RON A. JONES Vice President Oconee Nuclear Site

April 18, 2005

Subject: Oconee Nuclear Station Docket Numbers 50-269, 270, and 287 Technical Specification Bases (TSB) Change

Please see attached revisions to Tech Spec Bases 3.5.2 which was implemented on March 31, 2005.

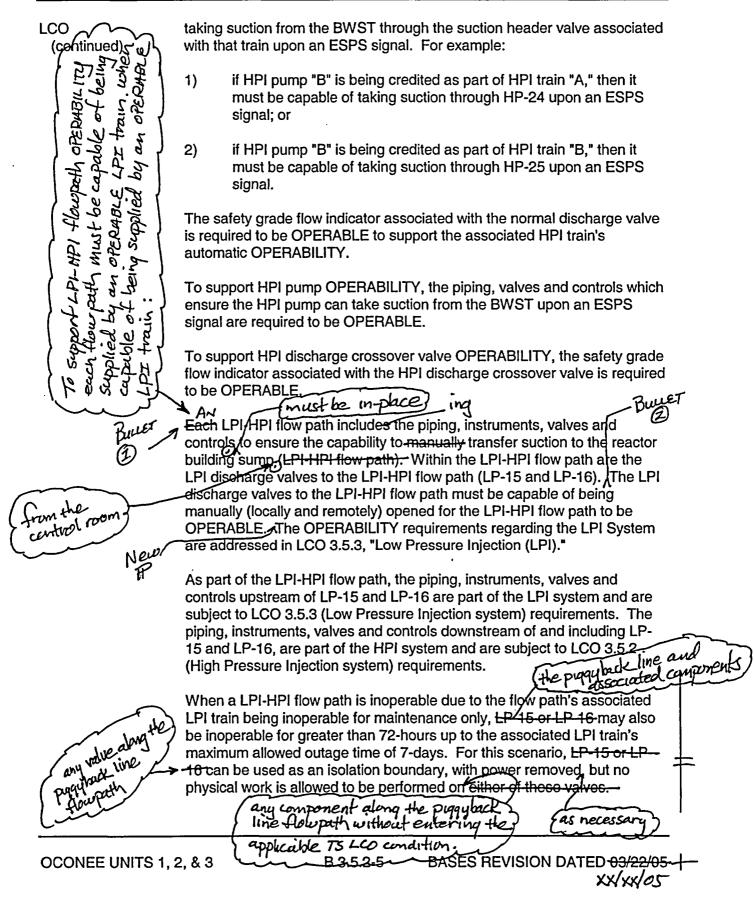
APPLICABLE SAFETY ANALYSES
 (continued)
 c. Maximum hydrogen generation from a zirconium water reaction is ≤ 0.01 times the hypothetical amount generated if all of the metal in the cladding cylinders surrounding the fuel, excluding the cladding surrounding the plenum volume, were to react;
 d. Core is maintained in a coolable geometry; and
 e. Adequate long term cooling capability is maintained.
 The HPI System is credited in the small break LOCA analysis (Ref. 2). This analysis establishes the minimum required flow and discharge head requirements at the design point for the HPI pumps, as well as the

requirements at the design point for the HPI pumps, as well as the minimum required response time for their actuation. The SGTR and MSLB analyses also credit the HPI pumps, but these events are bounded by the small break LOCA analyses with respect to the performance requirements for the HPI System. The HPI System is not credited for mitigation of a large break LOCA.
